Project Name : Land West of Kingfisher Grove, Three Mile Cross

Job No : 23-117

Note Title : Drainage Strategy Addendum 2

Date : February 2025

Figure 2.1: Outline Approved SuDS Landscape Plan (Left) vs Current (Right).

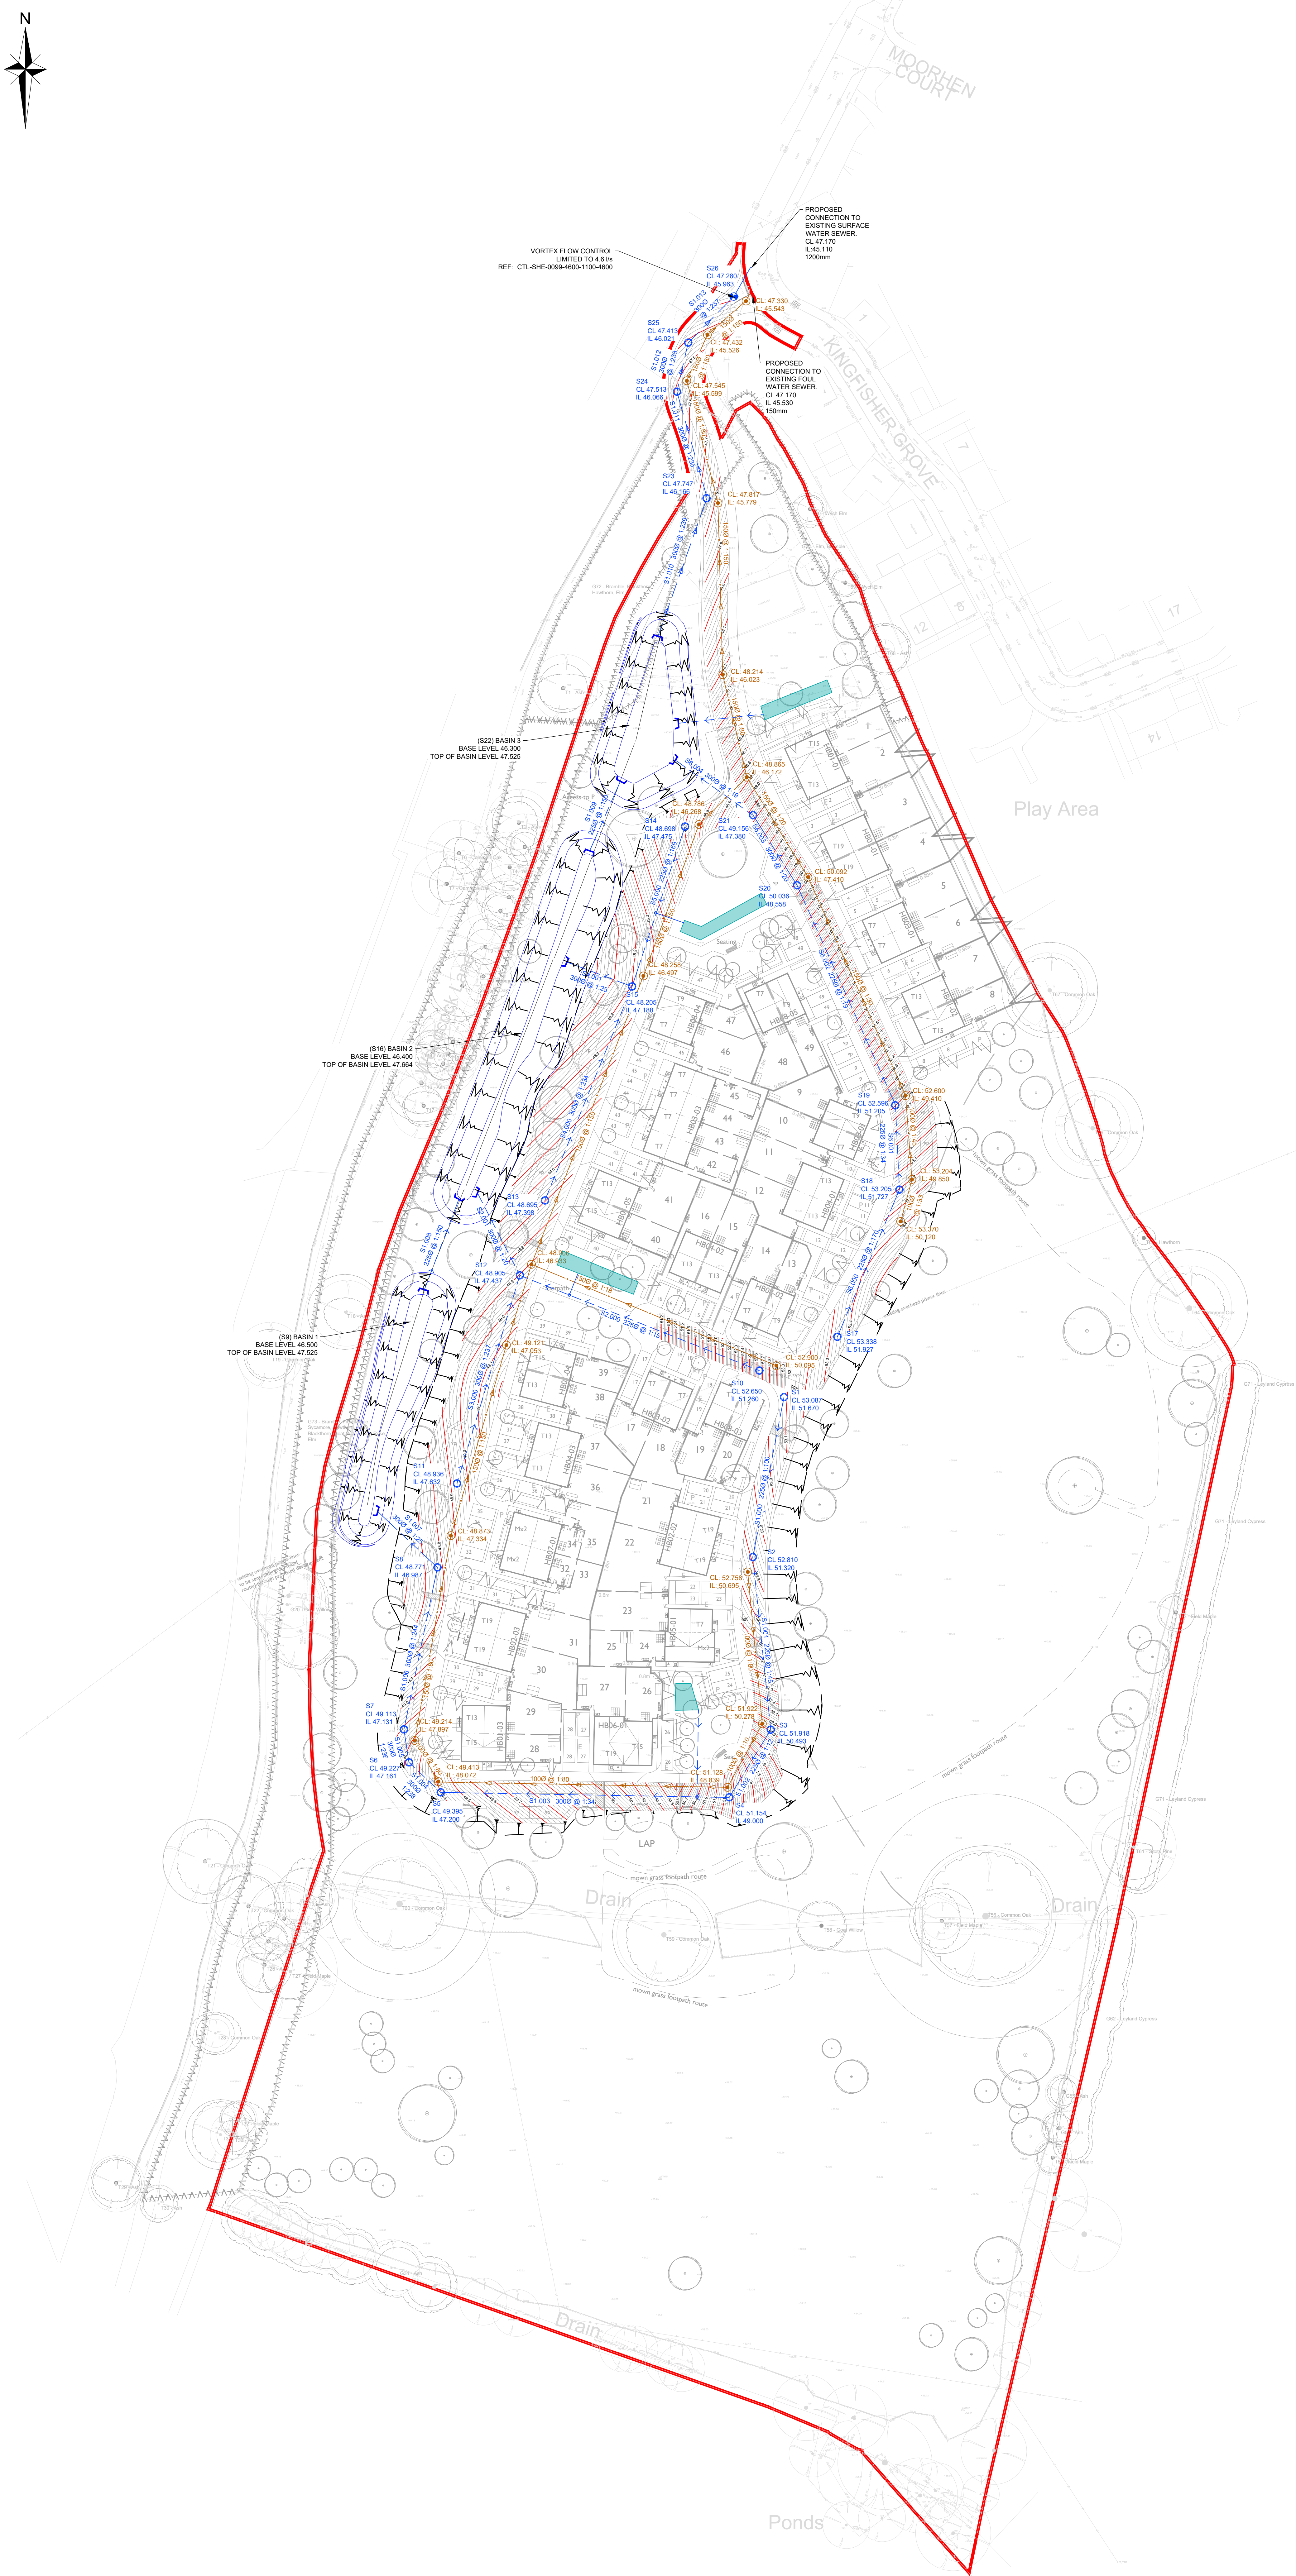
The proposed SuDS strategy relies solely on end-of-pipe solutions, such as detention basins and closed pipe systems, without incorporating a more holistic and integrated approach to surface water management. Given the ample space available within the site, there is a missed opportunity to implement a more sustainable, visually appealing, and multi-functional drainage strategy.

A well designed SuDS scheme should prioritise naturalistic and multi-benefit solutions that contribute to biodiversity, public amenity, and the overall landscape character. The scheme should explore the use of swales, tree pits, and rain gardens, which can provide effective water management while also enhancing ecological value and visual interest. These features should be designed to feed into a series of naturalistic basins that integrate seamlessly with the wider landscape, offering aesthetic value, informal recreation opportunities, and ecological function. A revised proposal should demonstrate how surface water management can be fully integrated into the development's landscape strategy to deliver both functional and placemaking benefits.

2.1.2 The proposed drainage strategy incorporates a series of elongated basins with surface water runoff being conveyed following treatment train from the most upstream basin to the last one before discharging to the outfall. The treatment train ensures that the holistic set of basins provides not only volumetric surface water attenuation but also water quality treatment and cleansing. This was agreed with the Lead Local Flood Authority (LLFA) at both the outline planning stage and as part of the reserved matters application.

2.1.6 The proposal to attenuate surface water flows using elongated basins is consistent with the approved outline strategy. However, the shape and formation of these has been redesigned to suit the updated site layout and existing topography. **Figure 2.1** shows the outline SuDS landscape plan (left) side by side with the current one (right), demonstrating that the approved drainage principles have been maintained in the current design. No sizing and 3D design of the SuDS features was undertaken at the outline planning stage. The basins have now been fully designed taking into account the topography as well as the total volume of surface water to be attenuated at the site up to the 1 in 100 year plus an allowance for climate change. A 10% increase in roof areas to account for urban creep has also been included in the calculations.

2.1.7 The SuDS features suggested at outline planning stage but not incorporated into the outline concept proposals pending detailed review included permeable paving, detention basins, swales, filter strips, and filter drains, however due to the steep gradients across the site, only the detention basin was suitable. This is outlined in **Table 2.2**:

2.1.8 The drainage scheme maximises the use of the public open space and basins have gentle side slopes hence offering great aesthetic value. One of the basins is designed to accommodate permanent water within it, this further increases the ecological and biodiversity benefits.

2.1.9 The rest of the areas designated as public open space to the east and south are too steep to incorporate conveyance features such as swales. The routes running east to west are too steep to include baffles to the swales. This is in conjunction with the proposed landscape plan.

2.1.10 Proposed rain gardens are shown indicatively adjacent to plots 1, 47, and 48. Other SuDS features such as downpipe planters, and additional small scale rain gardens will be utilised where possible.
